APPLICATION NO.	FILING DATE	FIRST NAMED INVENTOR	ATTORNEY DOCKET NO.	CONFIRMATION NO.
10/586,710	09/17/2008	Geoffrey Buddington	TYR-P0011	8721
27268	7590	12/27/2010	EXAMINER	
BAKER & DANIELS LLP 300 NORTH MERIDIAN STREET SUITE 2700 INDIANAPOLIS, IN 46204			BEDTELYON, JOHN M	
			ART UNIT	PAPER NUMBER
			2874	
			NOTIFICATION DATE	DELIVERY MODE
			12/27/2010	ELECTRONIC

Office Action Summary	Application No. 10/586,710	Applicant(s) BUDDINGTON ET AL.	
	Examiner JOHN M. BEDTELYON	Art Unit 2874

DETAILED ACTION

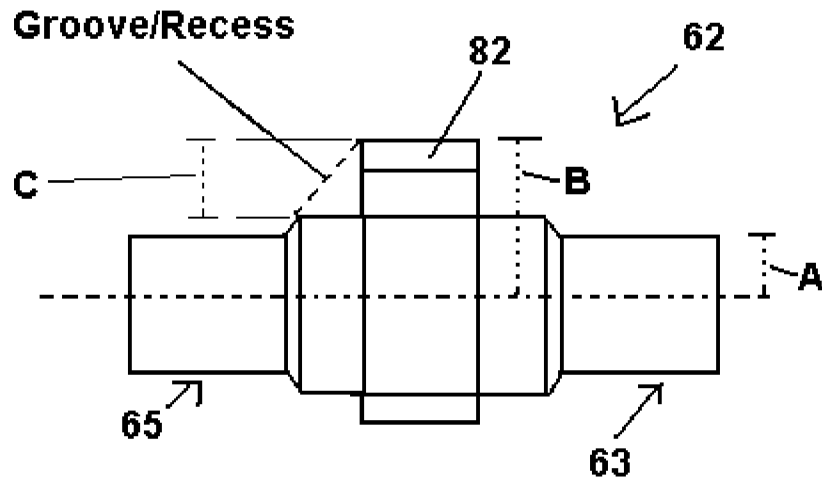
Applicant next argues McDonald fails to disclose a structure such that the portion of the crimp between the ends define a body portion has a dimension greater than that of the crimp tubes and which includes a recess for engagement by a closure housing, where the recess has a dimension less than that of the body portion (see page 4, last two paragraphs).

The Examiner respectfully disagrees. To clarify the Examiner's position, the Examiner has made a reproduction of the crimp band 62, as shown in figure 7, instead

viewed from the size, see below. This drawing is not made exactly to scale, but is intended to be used in conjunction with actual Figure 7, and is intended to show general relationships and portions discussed by the Examiner.

Additionally, the Examiner has annotated figure 5, see below.

Using the above figures for reference, the Examiner interprets the dimension of the body portion (B) as being greater than that of the dimension of the crimp tubes (A) (also see column 11, line 53 - column 12, line 9, which discusses the key portion 82 engaging the longwise extending passageway 84; the dimension of the body portion B, including the key portion 82, necessarily must be larger than the crimp tube dimension A in order to interact with the passageway component passageway 84 since if it were smaller, the crimp tubes would hit the passageway, not the key 83). Also, since the dimension of the recess (A) is shown to be a portion (i.e. some amount smaller) of the encompassing dimension of the body portion (B), the dimension of the recess (A) is necessarily smaller than the dimension of the body portion (B). That is to say, it can be seen that McDonald discloses the portion of the crimp between the ends define a body

portion has a dimension (shown by "B") greater than that of the crimp tubes (shown by "A") and which includes a recess (labeled Groove/Recess) for engagement by a closure housing (52) (see figure 5 above, the left side of the key 82 will engage with the portion labeled Engagement Portions of the plug body 14 at the leftmost portions of passageway 84, see column 11, line 61 - column 12, line 9), where the recess has a dimension (shown as "C") less than that of the body portion (shown as "B"). Thusly, McDonald meets the limitations of the claims.
